TOWN OF BERRYVILLE, VIRGINIA
REQUEST FOR PROPOSAL
Tree/Brush Removal and Tree/Brush Takedown Services
RFP # 2023-03

Addendum 3
Issued December 12, 2023

SUBJECT: Revised Work Area Plan Exhibits

PROJECT	TBVL122002
DATE	11-01-2023 (REV: 12-7-2023)
DRAWING SCALE	AS NOTED
DRAWN BY	CJM
APPROVED BY	MJY
WORK AREA #2 - ON-SITE / WATER TREATMENT PLANT	CS1501B
TOWN OF BERRYVILLE, VIRGINIA 101 CHALMERS COURT, SUITE A BERRYVILLE, VA, 22811	SHEET 1 OF 1

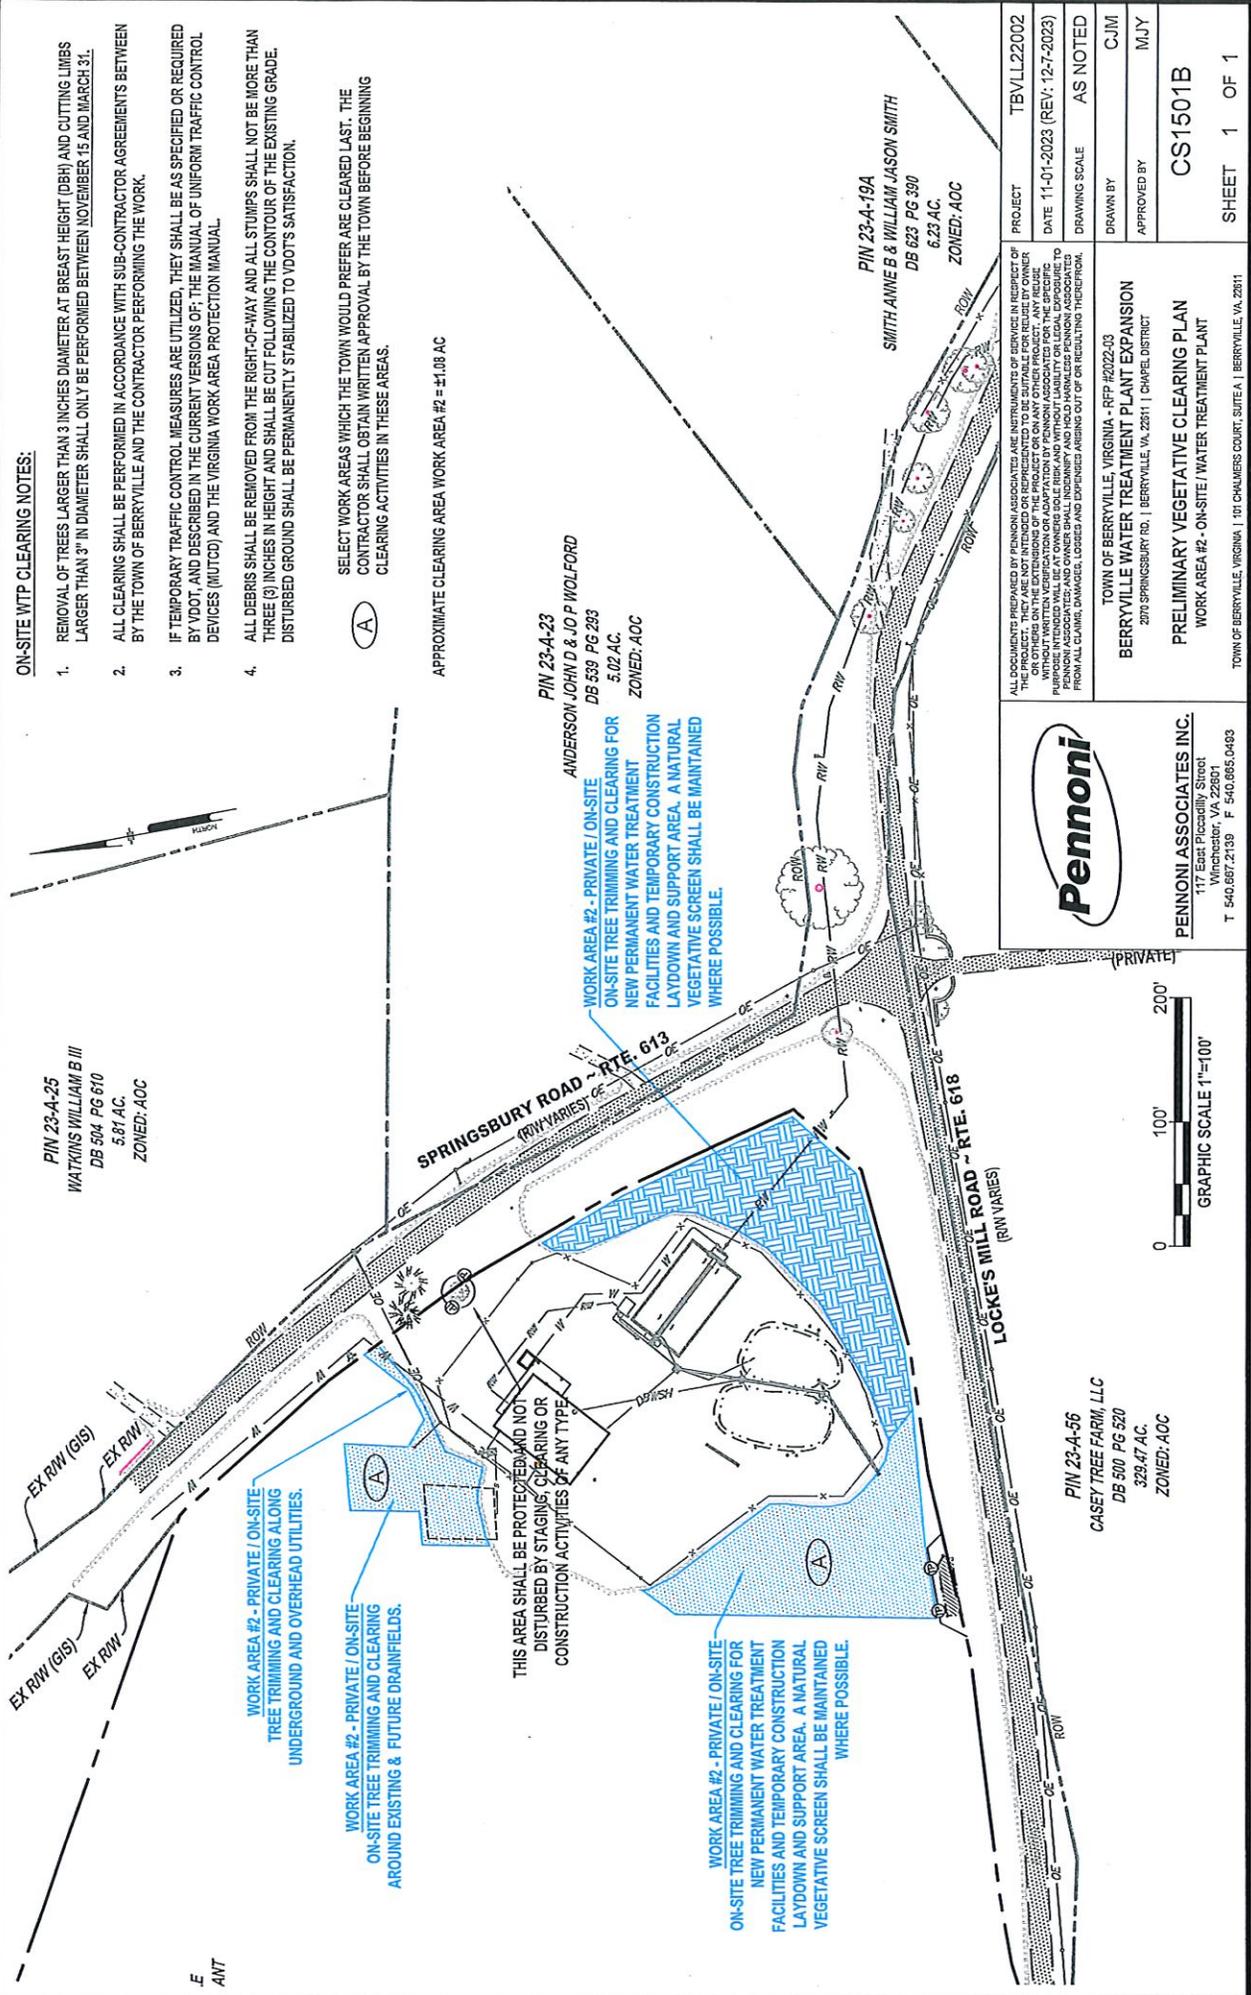
- Work Area #2 Exhibit
Amended hatch area for portions of the work area.

Added label and note for "Select Work Area", requiring Contractor to secure permission from the Town prior to commencing clearing activity in these portions of the site.

Tree protection areas added. Trees to be preserved will have an orange paint dot at the base of the tree. Orange flagging will also be installed around the trees to be preserved.

SELECT WORK AREAS WHICH THE TOWN WOULD PREFER ARE CLEARED LAST. THE CONTRACTOR SHALL OBTAIN WRITTEN APPROVAL BY THE TOWN BEFORE BEGINNING CLEARING ACTIVITIES IN THESE AREAS.

APPROXIMATE CLEARING AREA WORK AREA #2 = ±1.08 AC
